UNITED STATES
DEPARTMENT OF THE INTERIOR
BUREAU OF LAND MANAGEMENT
ARTESIA DISTRICT
FEB 06 2017FORM APPROVED
OMB NO. 1004-0137
Expires: January 31, 2018SUNDRY NOTICES AND REPORTS ON WELLS
Do not use this form for proposals to drill or to re-enter an
abandoned well. Use form 3160-3 (APD) for such proposals.
RECEIVED5. Lease Serial No.
NMLC029395B

☒ Oil Well ☐ Gas Well ☐ Other8. Well Name and No.
TURNER B 23

LINN RESPECTFULLY SUBMITS FOR YOUR REVIEW AND APPROVAL A PROPOSED PLAN FOR PLUG AND ABANDONMENT OPERATIONS AS FOLLOWS:

** BLM REVISED ** BLM REVISED ** BLM REVISED ** BLM REVISED ** BLM REVISED **

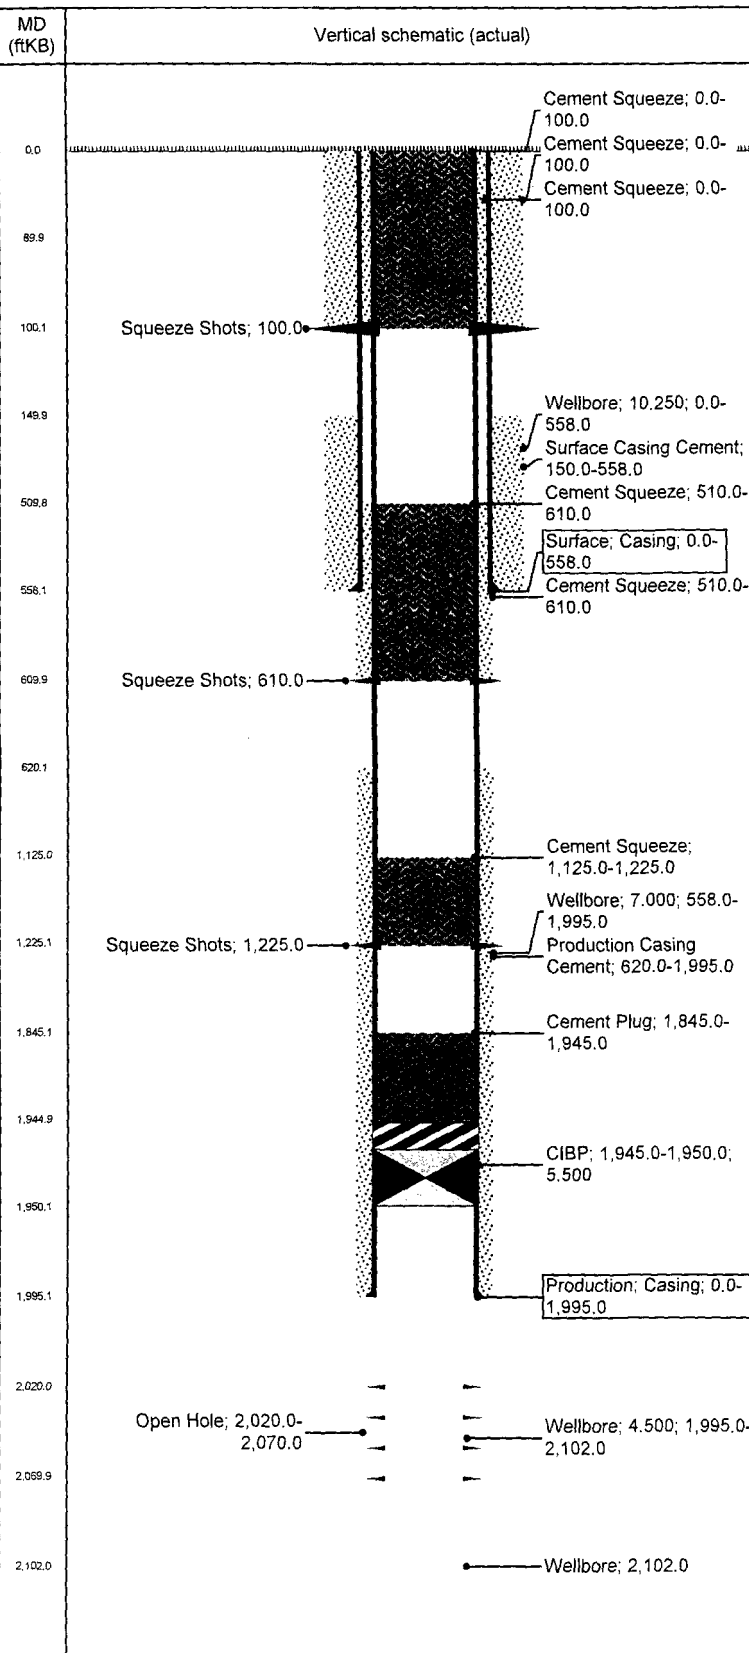
1. RIH W/TBG AND TAG CIBP @ 1945'. CIRC HOLE W/MUD LADEN FLUID.
2. PRESSURE TEST CSG. SPOT 25 SXS CMT @ 1945' - 1845'.
3. PERF & SQZ 25 SXS CMT @ 1225' - 1125'. WOC & TAG. 1373' - 1273'
4. PERF & SQZ 25 SXS CMT @ 610' - 540'. WOC & TAG. 407'
5. PERF & SQZ 35 SXS CMT @ 100' TO SURFACE.
6. CUT OFF WELLHEAD BGL & WELD ON DRY HOLE MARKER.

RECLAMATION PROCEDURE
ATTACHEDATTACHED FOR
CONDITIONS OF APPROVAL*Below ground level dry hole marker required*

Description	Top (ftKB)	Btm (ftKB)	Eval Method	Comment
Cement Plug	1,845.0	1,945.0		Spot 25 sks cmt at 1945'-1845'. Tag TOC.
Cement Plug	1,125.0	1,225.0		Perf & Sqz 25 sks cmt at 1225'-1125'. Tag TOC.
Cement Plug	510.0	610.0		Perf & Sqz 25 sks cmt at 610'-510'. Tag TOC.
Cement Plug	0.0	100.0		Perf & Sqz 35 sks cmt at 100' to surface.
Surface Casing Cement	150.0	558.0		Cemented w/ 50 sxs of class "C" cement.
Surface Casing Cement	0.0	100.0		Perf & Sqz 35 sks cmt at 100' to surface.
Production Casing Cement	620.0	1,995.0		Cemented w/ 100 sxs of class "C" cement.
Production Casing Cement	510.0	610.0		Perf & Sqz 25 sks cmt at 610'-510'. Tag TOC.
Production Casing Cement	0.0	100.0		Perf & Sqz 35 sks cmt at 100' to surface.
